Product Change Notification / GBNG-02EIPE100

CCB 6067 Initial Notice: Qualification of STAR as an additional final test site for MICRF221AYQS and MICRF221AYQS-TR catalog part numbers (CPN) available in 16L QSOP (3.90mm) package.

CCB 6077
Pre and Post Change Summary
PCN #: GBNG-02EIPE100

PCN #: GBNG-02EIPE100

Pre and Post Change – Plastic Reel

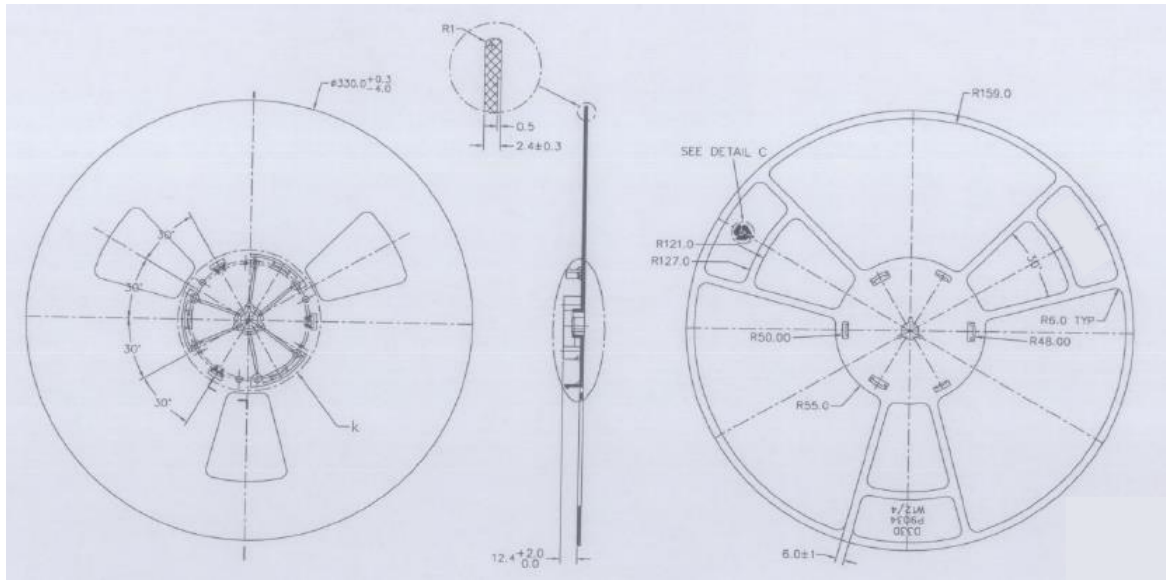
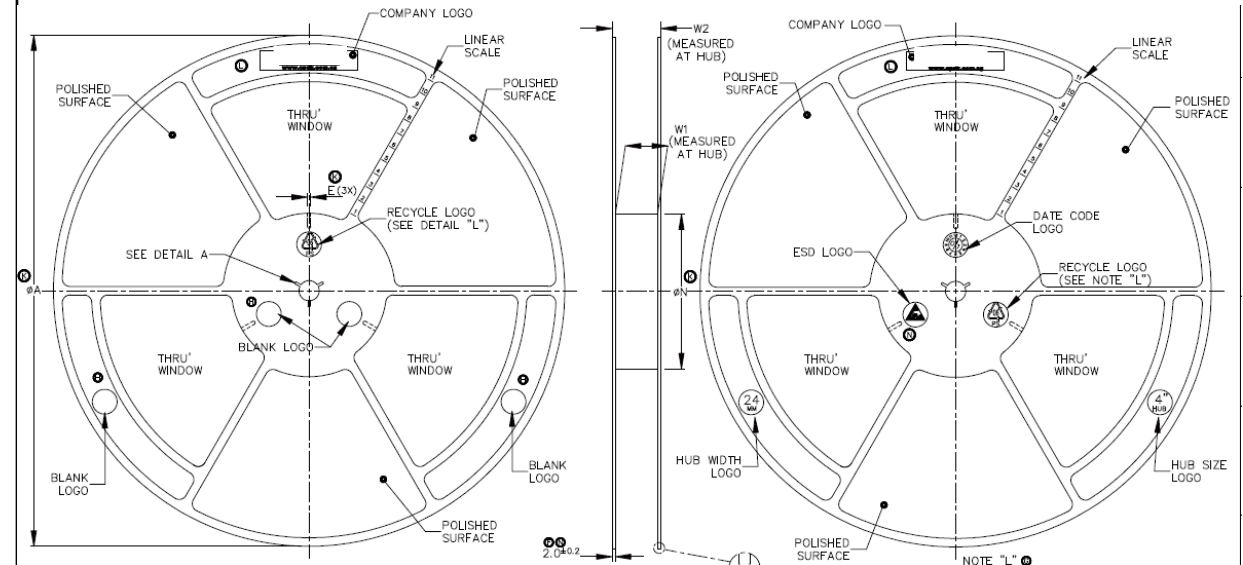
No dimension change.

Pre and Post Change – Carrier Tape

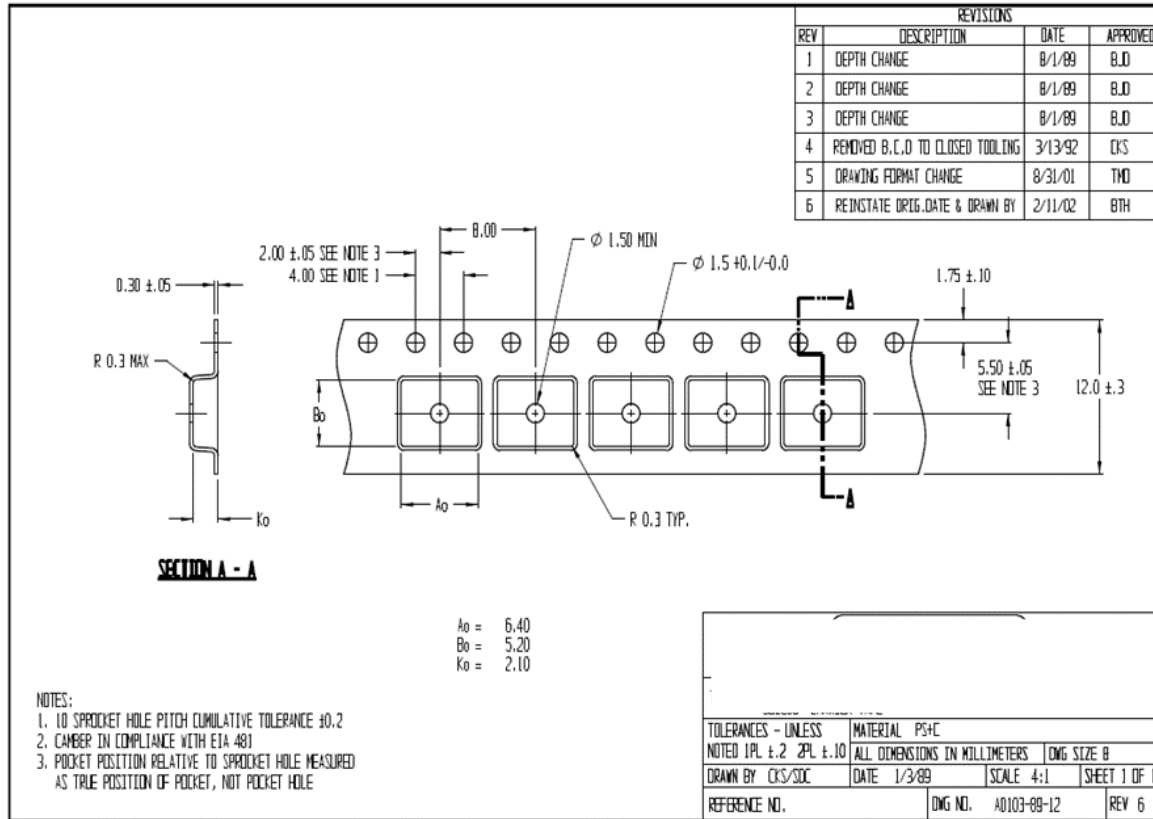
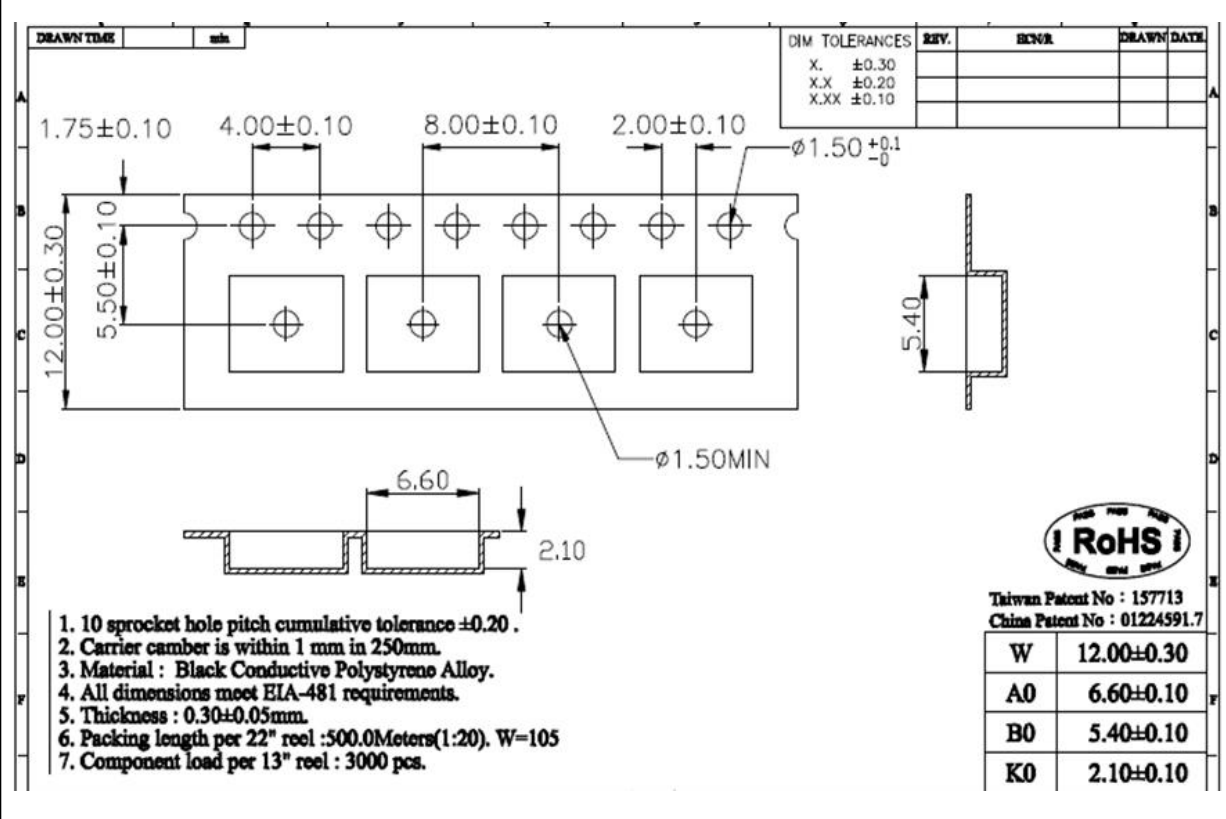
Plant	W (mm.) ± 0.3 or Specific	P (mm.) ± 0.1 or Specific	A ₀ ± 0.1 or Specific	B ₀ ± 0.1 or Specific	K ₀ ± 0.1 or Specific
UNIS	12	8	6.40	5.20	2.10
STAR	12	8	6.60	5.40	2.10

Pre and Post Change – Cover Tape

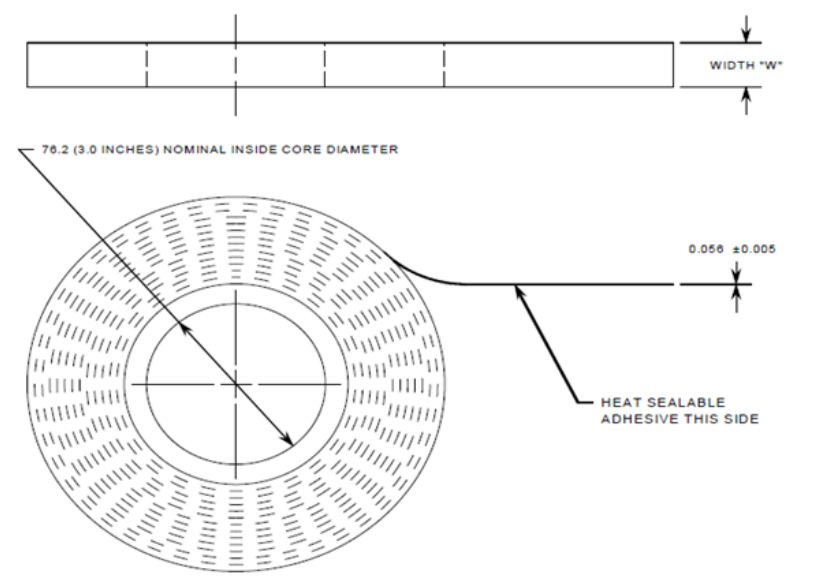
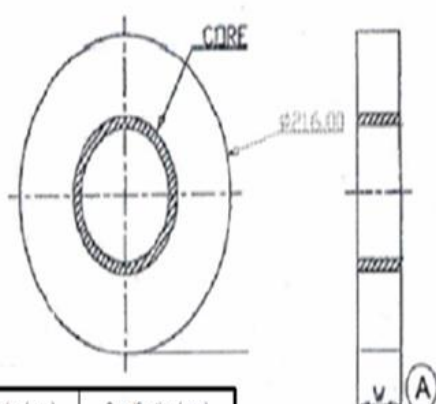
Plant	Carrier Tape Width	Cover Tape Width	Thickness	Color	Sealing mythology
UNIS	16mm	13.3 +/-0.1mm	0.056+/-0.005	Clear	Heat sealing
STAR	16mm	13.3 +/-0.2mm	0.050+/-0.005	Clear	Heat sealing

Pre and Post Change – Tube

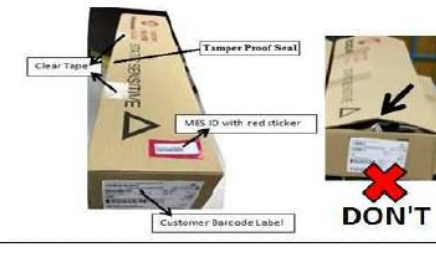
UNIS	STAR
BQM (Base Quantity Multiple)	98 units	98 units
Pin 1 orientation	<p>Pin 1 toward white stopper</p> 	<p>Pin 1 toward grey stopper</p> 
Tube Color	Clear tube	Clear tube
Plug Color	Full Tube: White – Black Partial Tube: White – Yellow	Grey-Grey
